BURLINGTON DEVELOPMENT REVIEW BOARD

Tuesday April 21, 2015

- 2. 15-0801PD; 140 Grove St (RL, Ward 1) Ireland Grove Street Properties**
Final plat review of PUD to demolish existing concrete plant and buildings, construct 19 new buildings for 232 residential units, clubhouse, and maintenance building with associated road, parking, and site improvements (Project Manager, Scott Gustin)

DATE: 7-23-14
JOB: 2011-02-09
PLAN SHEET: S3

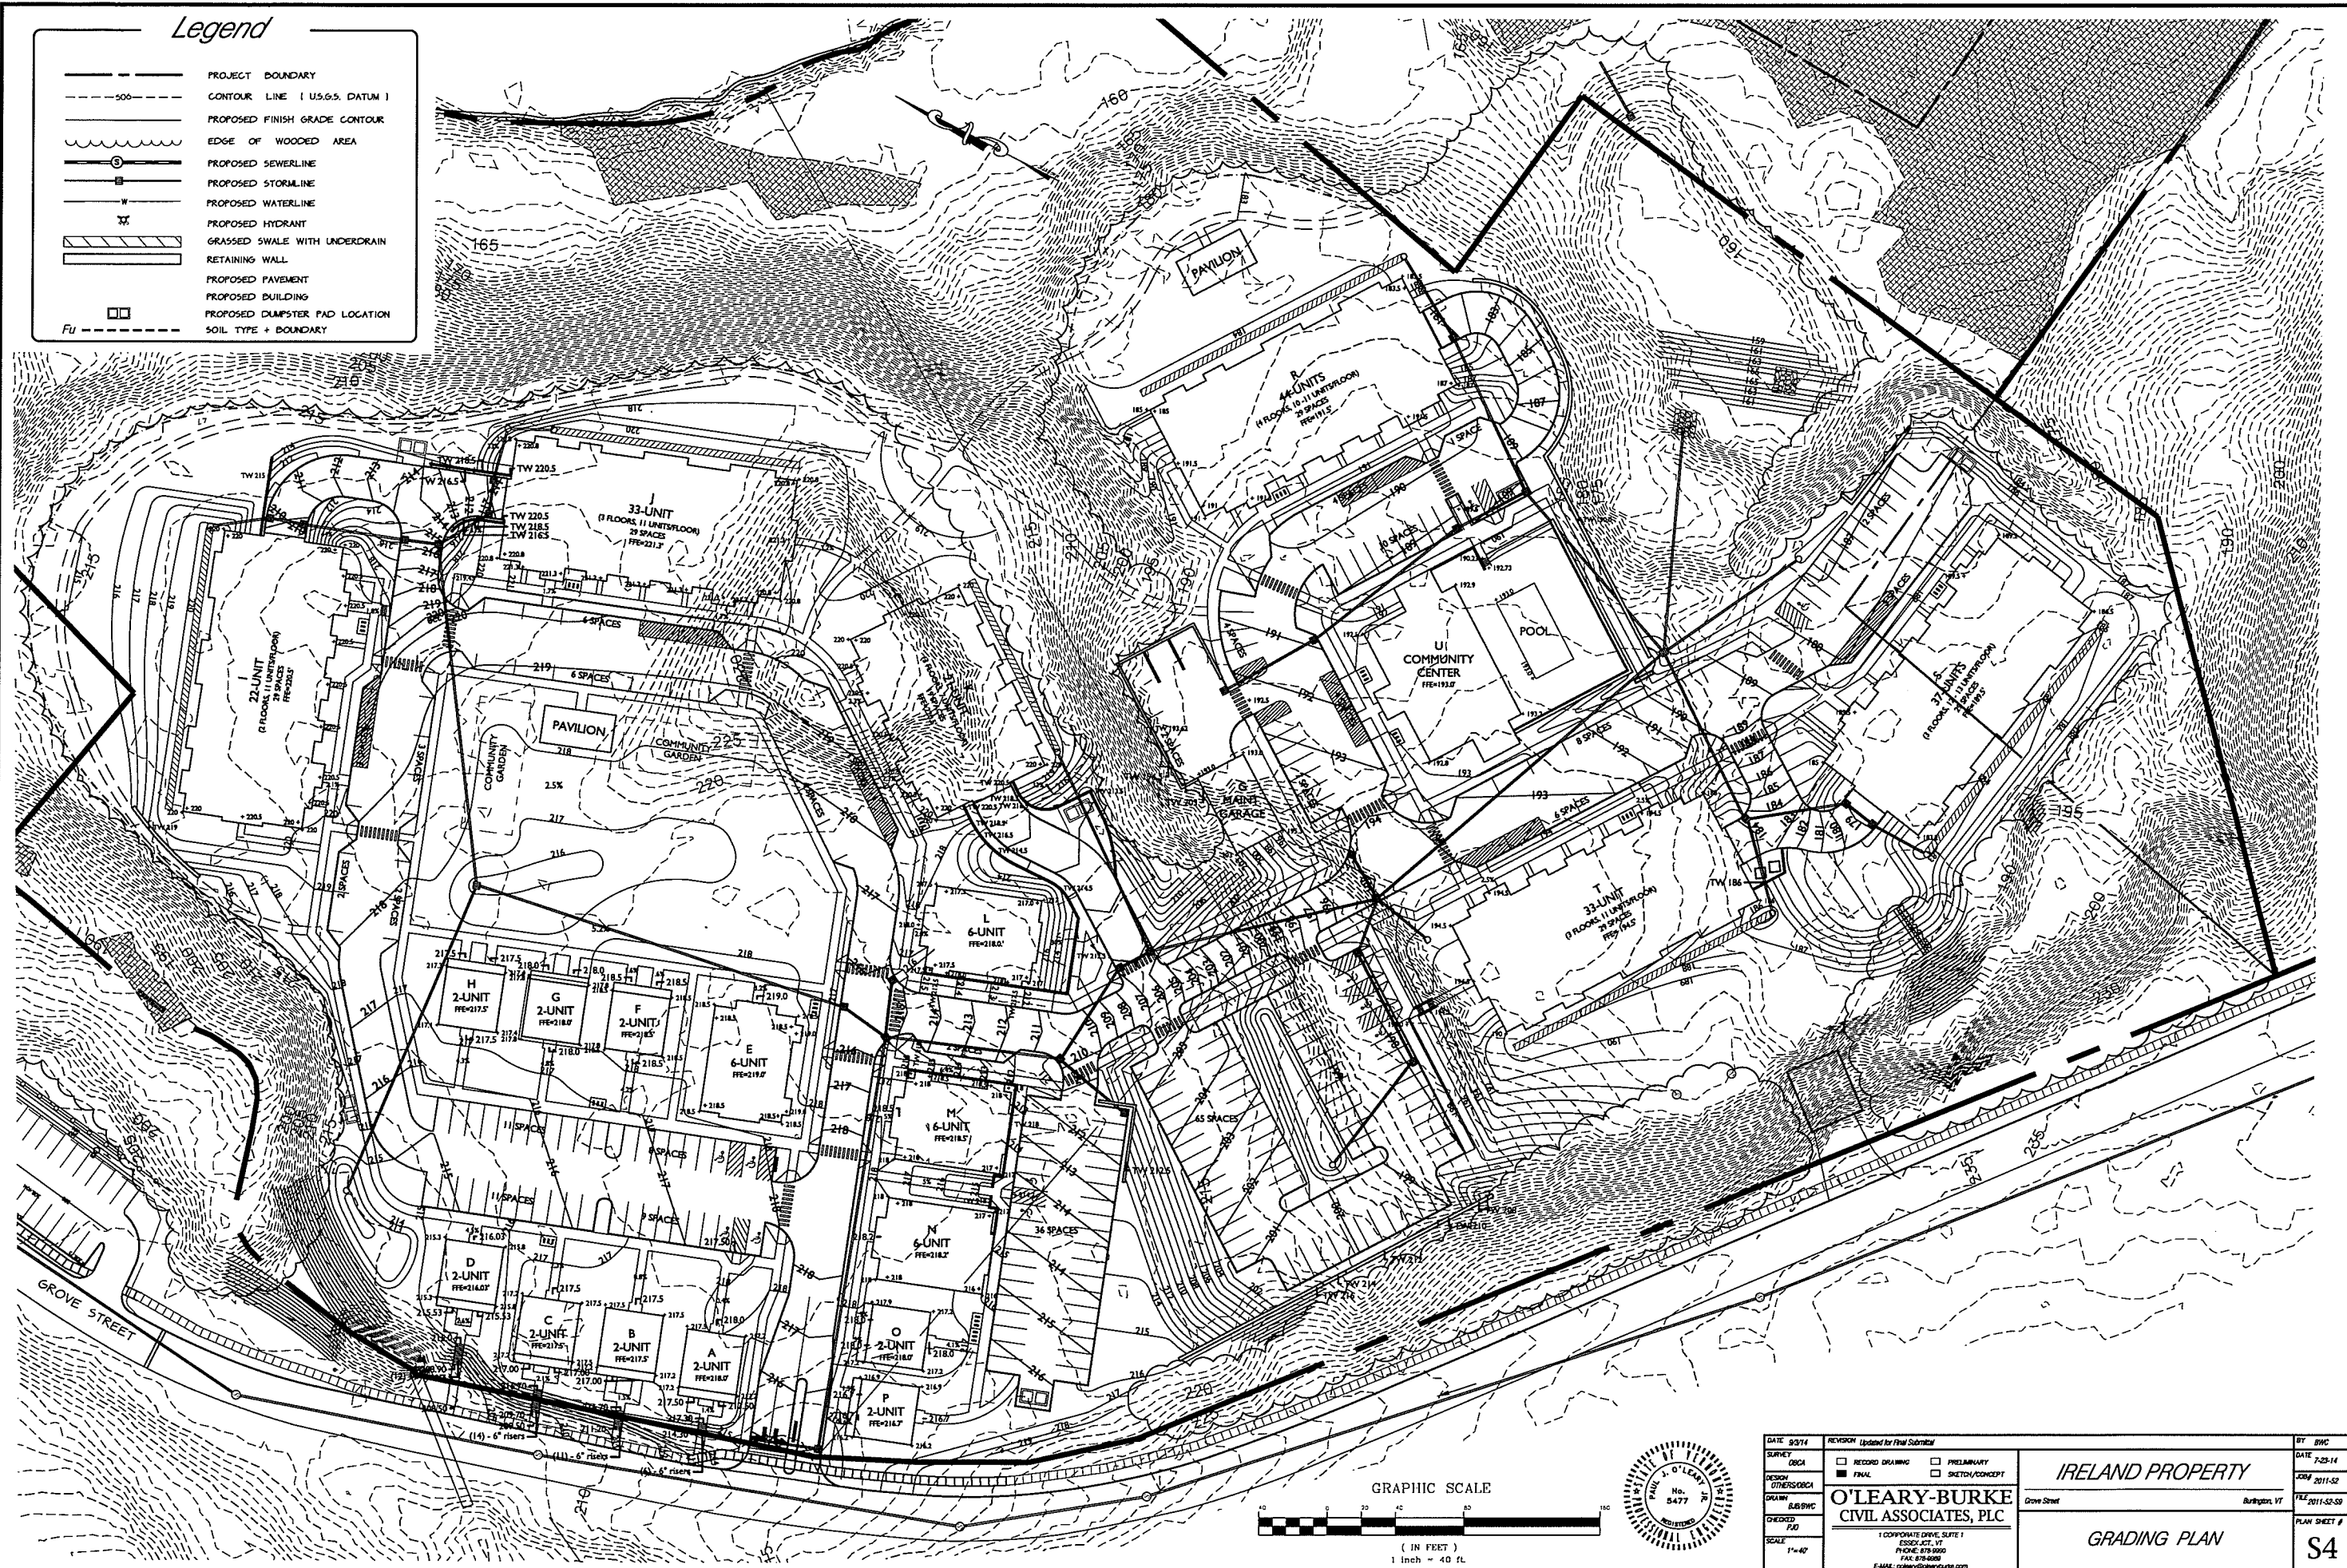
1. The Utility Plan (Sheet S3) calls for C900 pipe but the Water Detail (Sheet S16) has a DI pipe specification under PVC Pipe and DI fittings. Change S16 sheet to include the C900 DR14 (305 psi) PVC pipe spec and C907 for molded PVC fittings. Include tracer wire, tracer wire test stations (if valves are >500' apart) and magnetic warning tape stating "Caution – Buried Water Line Below" approximately 3' below grade. We use tracer wire and test stations from Copperhead Industries.

Sheet S3 – Utility Plan has been updated to show an access easement to the City for pump station and force main maintenance.
There's nothing found on S3 pertaining to this. Easement will need to be a separate, legal, document.

Sheet S3 – Utility Plan has been updated to have gate valves on each leg of the tees proposed with the new 8" C900 water main. OK, great.

Sheet S3 – Utility Plan has been updated to show a proposed hydrant within 100' of Building I. The hydrant is proposed to be located west of the building. OK, great.
